MCF5271 Chip Errata

Silicon Revision: All

This document identifies implementation differences between the MCF5270 and MCF5271 processors and the description contained in the *MCF5271 ColdFire® Reference Manual*. Refer to <http://www.freescale.com/coldfire> for the latest updates.

Figure 1. Buffer Overrun Example

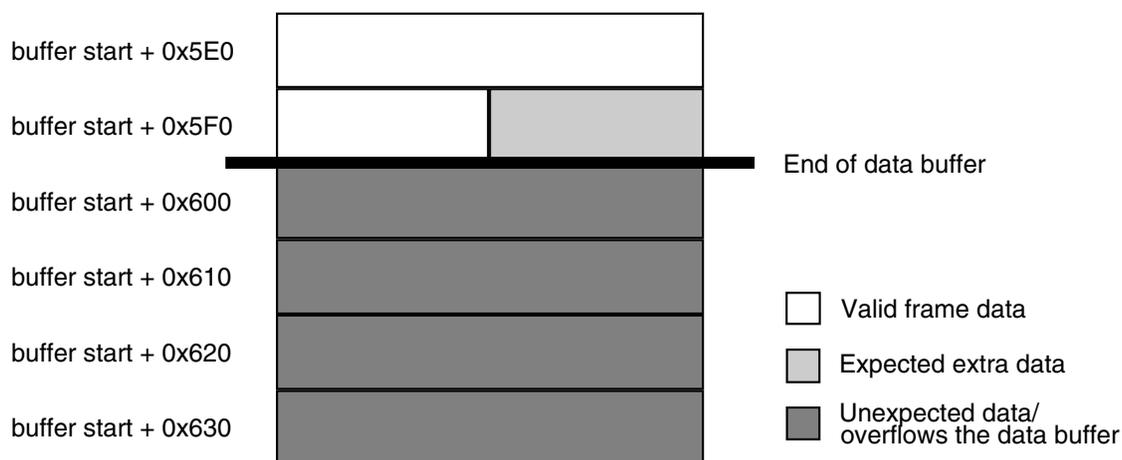
Description: When the FEC is connected to a 10BaseT network, if length of the data stored in a descriptor is not evenly divisible by 16 (not line-aligned), the FEC writes extra lines at the end of the buffer. The entire line that contains the last valid data is written and at least one extra line, but up to four lines after the end of the valid data can also be written. In most cases, this is not a problem because the extra lines of data continue falling within the limits of the buffer. However, if the valid data ends near the end of the buffer, the extra lines written by the FEC might be outside of the data buffer. This leads to corruption of the next buffer, descriptor, data, or code stored in the adjacent memory.

For example, as shown in the figure below, if the max buffer size is programmed to 0x600 and a frame that is 0x5F8 bytes long is received, a line is written starting at buffer start + 0x5F0. The first half of the line at buffer start + 0x5F0 is valid frame data that should be processed by the FEC driver; the second half of the line is additional data that is written because the FEC only writes complete lines. This data should be ignored by the FEC driver. So far, this is correct FEC behavior as originally specified. However, the FEC repeats the last line of valid data a number of times. The line at buffer start + 0x600 is written, and as many as three additional lines beyond the end of the data buffer could be written.

Workaround: Only use 100BaseT.

Workaround: Allocate extra lines for the receive data buffers. The actual allocated memory for each buffer should be equal to the receive buffer size programmed in the FEC's EMRBR register plus four lines (16 byte-sized lines).

Workaround: Program the data buffer size one line larger than the max packet size (data buffer size = EMRBR + 0x40).
